### RECONVENED MEETING OF ARGYLL AND BUTE LOCAL REVIEW BODY

## 17/0005/LRB

Amendment to Condition 4 of Planning Permission in Principle 17/00493/PP granted on 02/05/17 (requirement for surfacing in a bituminous surface to a point 10 metres south of the access into the site)

Site for erection of dwellinghouse on land North of 1 Kilvaree, Connel

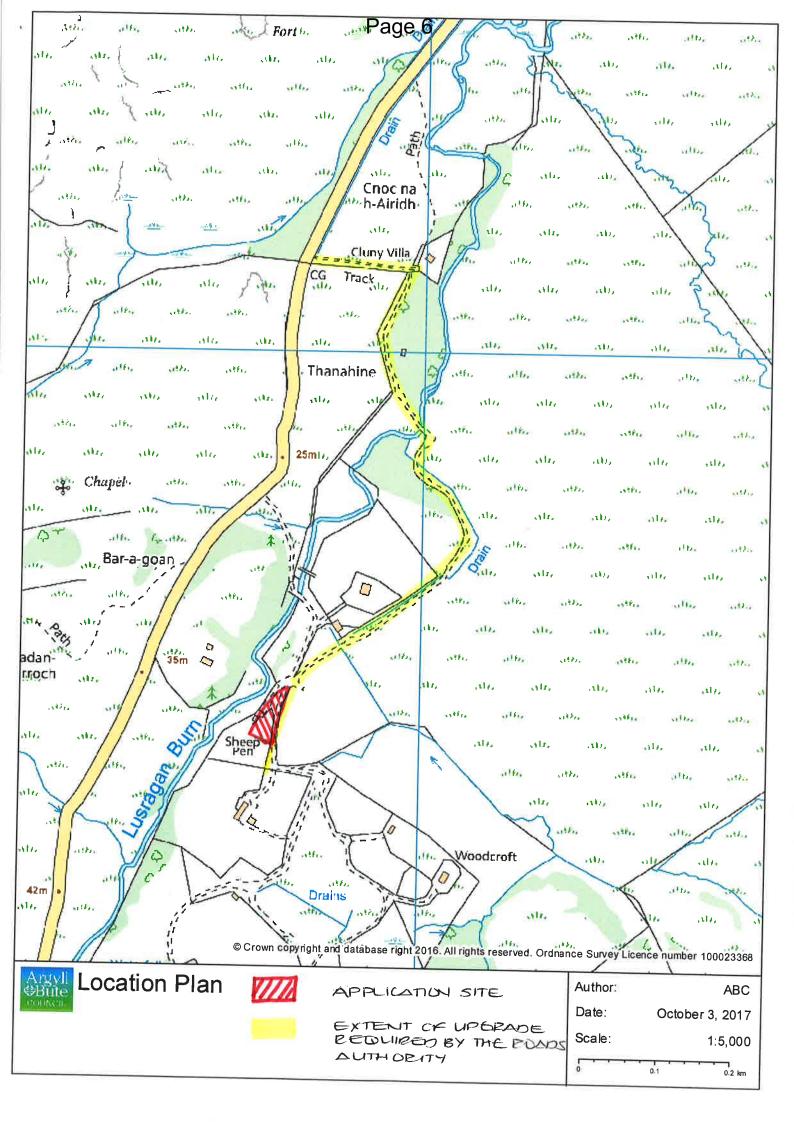
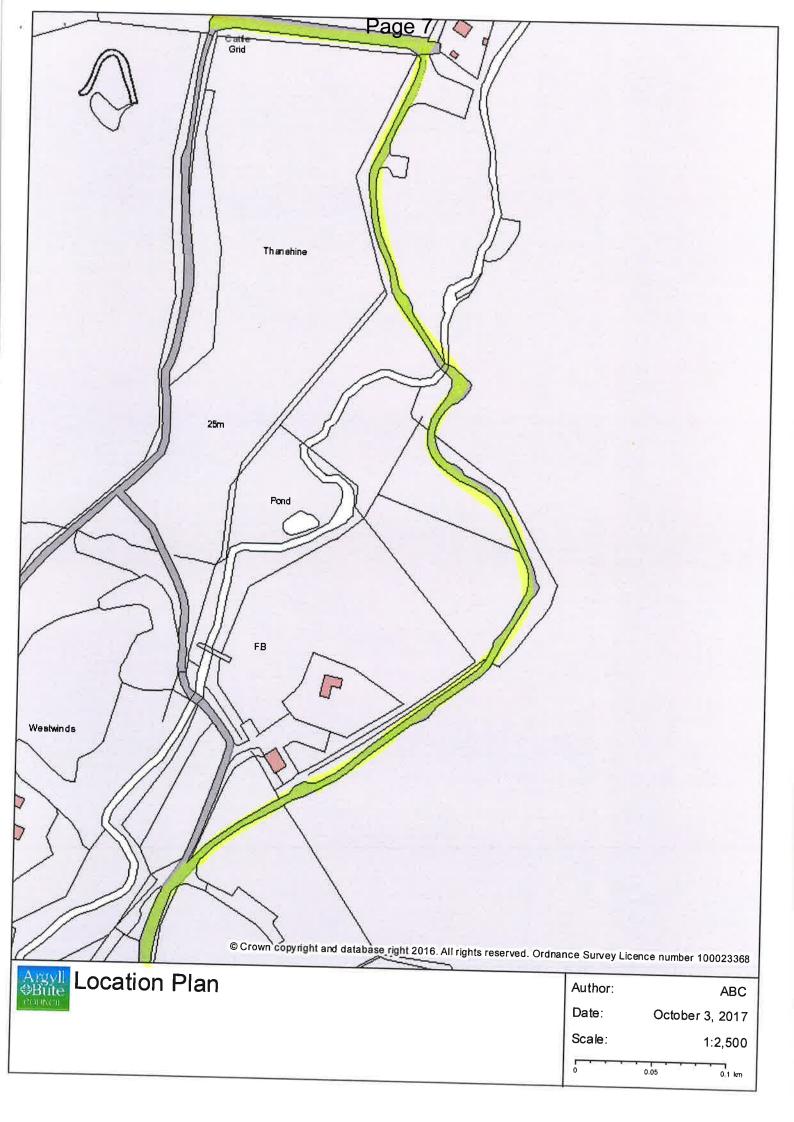
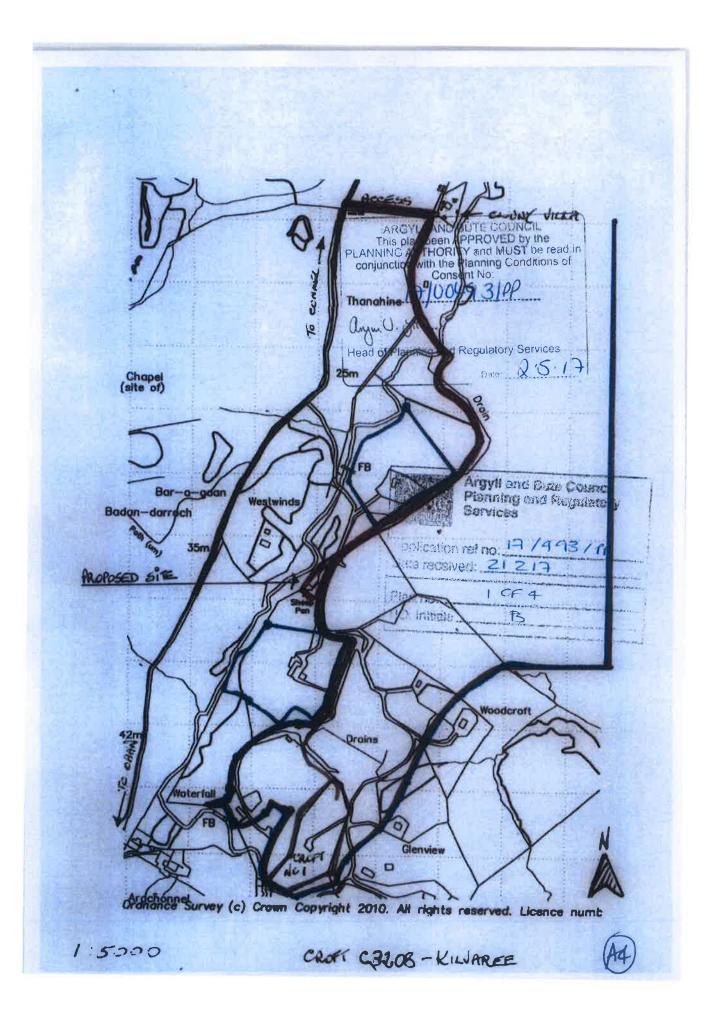
i) To provide clarity as to the length of access to be improved as referred to in Condition 4.

Comment: The access is to be improved from its junction with the public road to a point 10 metres south of the access into the proposed development site (approximately 900 metres) – see attached plans.
